Track Control arm
BMW (E36)

Sidem Nr.
21370 R
21371 R

Reference nr.
31 12 6 758 513
31 12 6 758 514

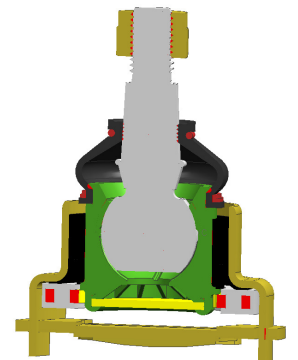
Problem:

- Early wear of rubber bedding Ball Joint.
- Play on ball joint.

Cause:

- Weak connection by rubber between inner and outer bushing.
- When replacing a ball joint, special equipment is needed to press it in the arm to prevent damage.
- Damaged dustcover.

! When the arm with rubber bedding is replaced by the improved version, replace both left and right arm !

Solution:

- A new ball joint is progressed without the rubber core.
- A cover is added to protect the pin and the dustcover during transport and storage.
